DA 22/11272

Alpine Coaster and Associated Works

Response to Additional Information Request

December 2022

Figure 1: Existing light poles in the vicinity of the Development

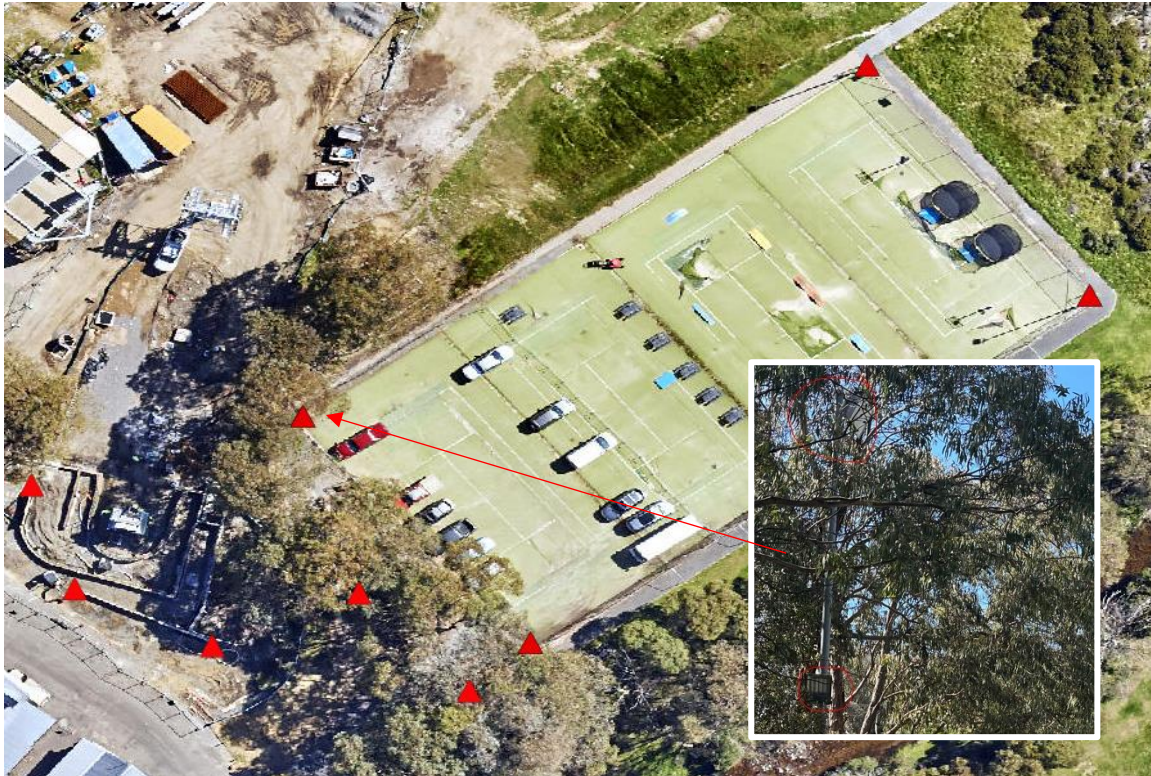
If/when night-time operation is proposed, provide details of all current and proposed lighting to be provided on and adjoining the coaster facility. This should include details of the lighting on the coaster equipment, and provision of a lighting plan and light spill information detailing the location and nature of lighting to be provided on the line, the customer waiting areas, carpark and pedestrian pathways to and from the site.

- *Coaster track/alignment* – No lighting will be provided.
- *Customer waiting areas* – Low-level lights will be fitted on the canopy of the queueing area at Bottom Station.
- *Carpark and pedestrian pathways* – The existing light poles (LED flood lights) (refer **Figure 1**) in the vicinity provide sufficient lighting along the existing footpath for pedestrians travelling between Woodridge and Valley Terminal.

Given the proposed low-level lighting will be located on the underside /canopy of the bottom station building, and no additional light poles are proposed, the provision of a lighting plan and light spill information is not warranted.

Figure 2: Example of trestle footing

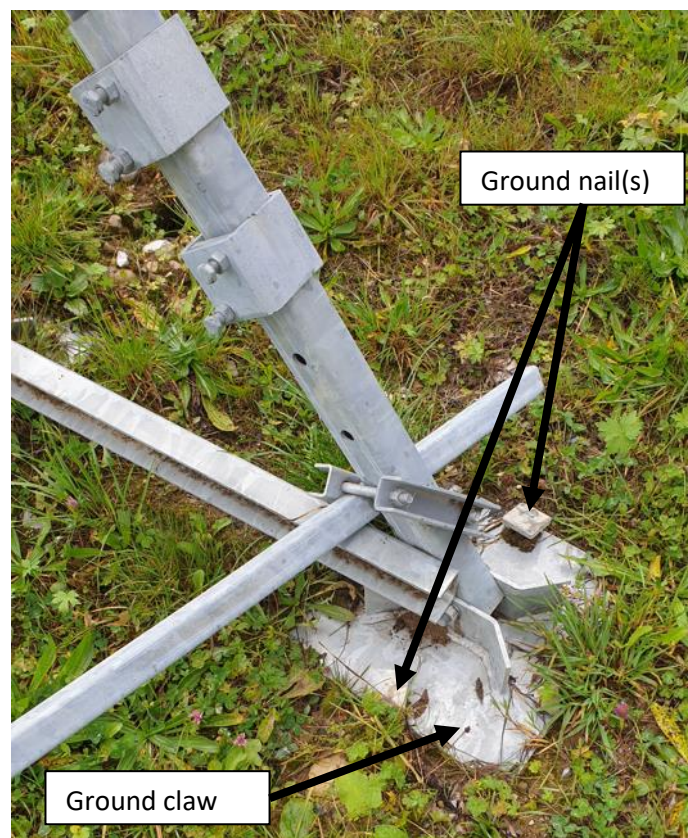
Ground stakes and support wires, including (but not limited to) how many and where, particulars of how far out they extend, how they will be clearly identified for all recreational users in the locality (also refer to safety considerations requested elsewhere).

Structural supports are of two general types:

- Those that require a concrete footing and tubular steel tower. The location of these are shown in Error! Reference source not found.).
- The trestle type that require only ground nails (stakes) to secure their footing plate (claw) without the need for a concrete footing. These vary in height according to the ground profile and would be installed at 3 m intervals along the majority of the uphill and downhill track wherever there are no tubular type towers. On the downhill track there will be approximately 270 trestle type supports with another approx. 90 on the uphill track making a total of 360 such supports. Trestle supports on curves require four ground nails per support, those that support straight sections of track require only two per support. Typical specifications are provided in **Appendix D**. Ground nails (stakes) do not require identification as they finish flush with the footing plate, refer **Figure 2**.

Figure 11: Existing Directional Signage and Fencing around Operational Staff Carpark

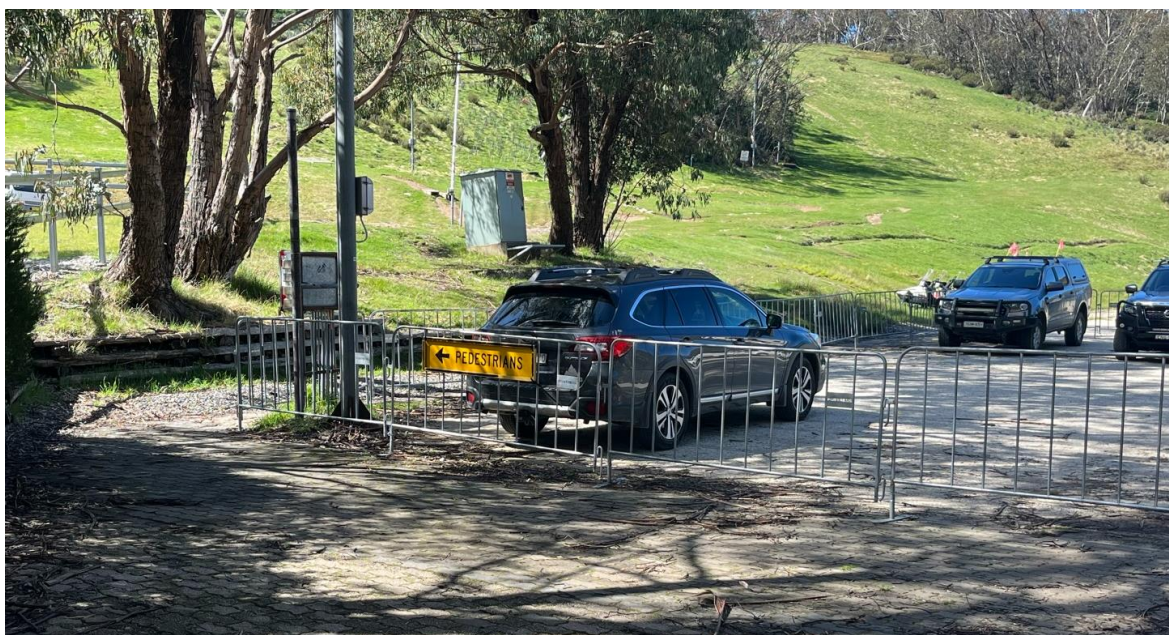
Separation of vehicles and pedestrian pathways for staff

The separation of vehicles and pedestrian pathways within the Valley Terminal precinct (including the disused tennis courts / staff carpark) is currently managed through fencing and directional signage (refer **Figure 10** and **Figure 11** for example). KT will continue to manage pedestrian and vehicle access with this approach. The replacement of crowd control type fencing (**Figure 11**) with new timber fencing around the existing operational staff carpark will also improve the aesthetics of the locality.
